Mr F Gardner Case Officer, Planning Department
Arun District Council, Maltravers Rd.
Littlehampton, West Sussex, BN17 5LF

OBJECTION - BR/93/21/PL - 22 Neville Road PO22 8BN

Above: morning 6.30 am 19th April 2021

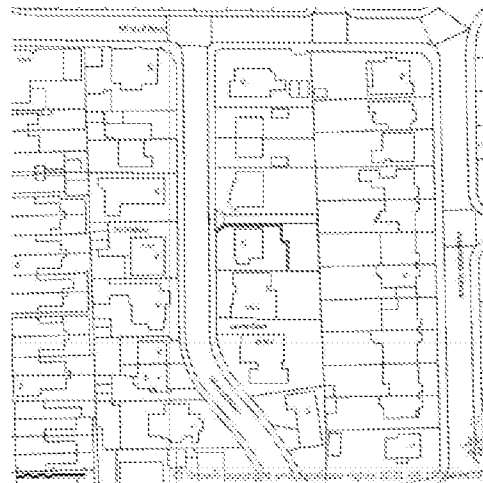
The living accommodation and external amenity area would be both cramped and oppressive, such as to result in a poor outlook from habitable accommodation which will be poorly lit (see photographs page 2). The proximity of the dwelling will disturb existing occupants due to the movement and noise of vehicles and those directly overlooking a proposed flat roof replacing the view of the garden. The loss of a garden contributes to the loss of biodiversity. A garden contributes to good physical and mental health. The applicant proposes removing this amenity from the existing tenants of 22 Neville Road.
